FURTHER INFORMATION RESPONSE REPORT

Large Scale Residential Development

**Lands at
'St. Teresa's,'
Temple Hill, Temple Road,
Monkstown,
Blackrock,
Co. Dublin**

**Dún Laoghaire Rathdown Co. Co.
Reg Ref – LRD26A/0051/WEB**

Figure 1 – Revised layout of storage rooms C and D

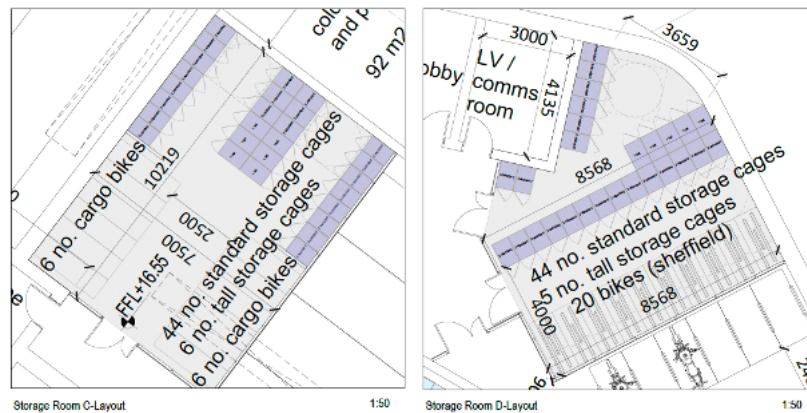
(b) Bulky Storage: Having regard for Section 12.3.5.3 Internal Storage and External Storage of the Development Plan suitable bulky storage shall be provided for within Block D1 and E1-2. The current provision is not considered usable or well distributed.

We wish to clarify that the proposal as lodged in January 2026 contained bulk storage in 2 no. storage rooms located within Block D1 basement level. Up to 44 no. full height units or up to 88 no. units if stacked, could be provided at basement level. Under the current proposals prepared and submitted as part of this Further Information response by O’Mahony Pike Architects these storage areas are referred to as Storage Room C and D.

car park area. The greater visibility / transparency now proposed will ensure the safety of the user and also reduces the likelihood of anti-social behaviour occurring.

Both Storage room C and D double up as bicycle storage, sharing the circulation space and getting greater efficiency from the available space.
